# SERVICE BULLETIN

B-063A

Safety Recall Code 0832

## SIDESTAND ASSEMBLY REPLACEMENT FOR 2006 ULYSSES XB12X

Figure 1. Old Pivot Bolt and New Pivot Pin with Circlip

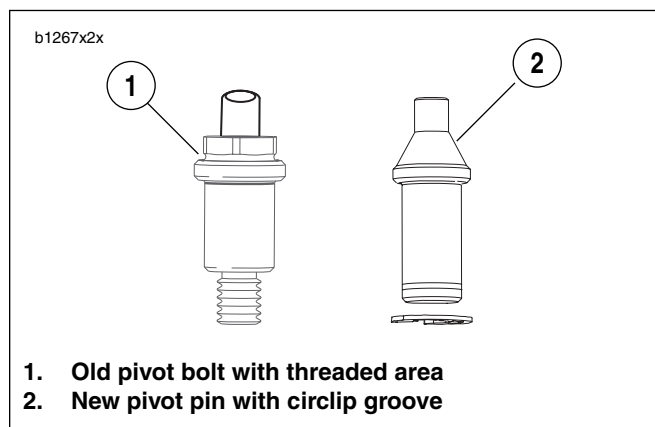
Either the pivot bolt for the sidestand leg or the mounting bracket bolts could break, possibly without notice. If either of these failures occurs, the motorcycle could fall, possibly causing death or injury.

See Figure 1. The correction for this issue is to replace the sidestand assembly and fasteners. The recall kit Part No. is 94483Y.

Figure 3. Sidestand Assembly (Extended)

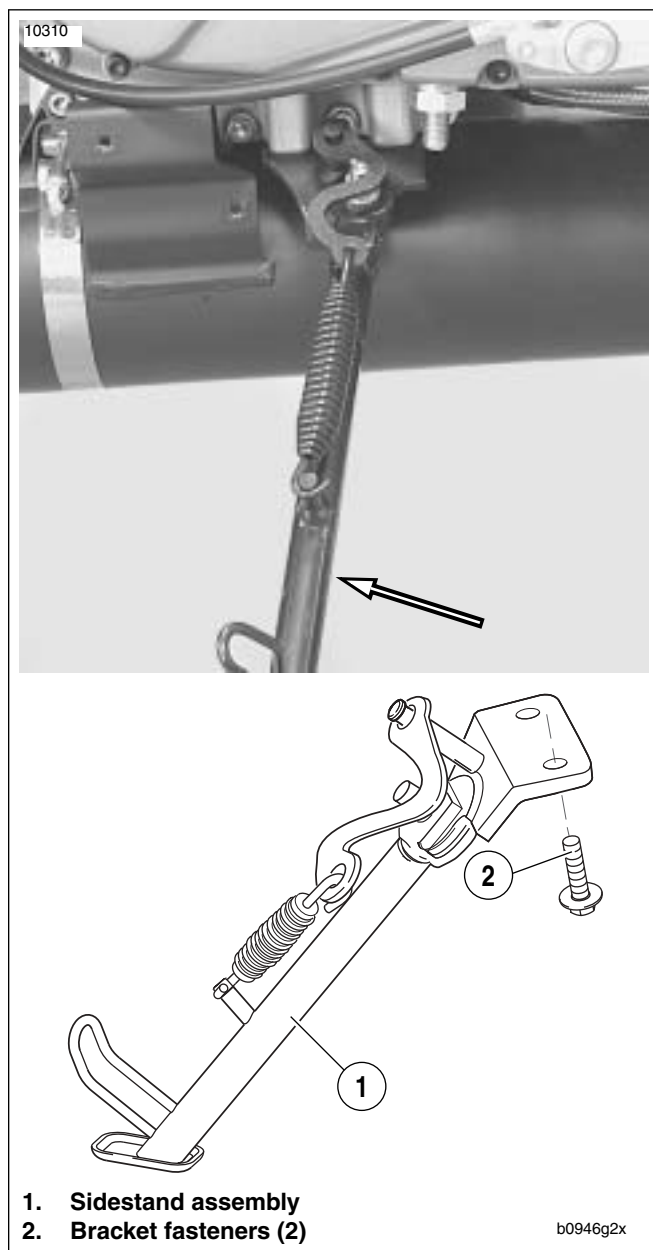
1. See Figure 3. Loosely install the sidestand assembly (1) to the crankcase with **new** sidestand bracket fasteners (2) provided in recall kit. Extend the sidestand leg (1) and hold forward in the fully extended position while tightening the sidestand bracket fasteners (2) in the following sequence:
  - a. Tighten the front fastener to 25-27 ft-lbs (34-37 Nm).
  - b. Tighten the rear fastener to 25-27 ft-lbs (34-37 Nm).
  - c. Repeat the tightening sequence in step a and b to verify proper clamp load.
2. Install muffler using **new** Torca clamp and front muffler strap provided in recall kit. See Muffler and Straps in 2.32 EXHAUST SYSTEM in Ulysses Service Manual.
3. Install chin fairing fasteners. See 2.38 CHIN FAIRING in Ulysses Service Manual.
4. Extend and retract sidestand leg to check for proper operation.
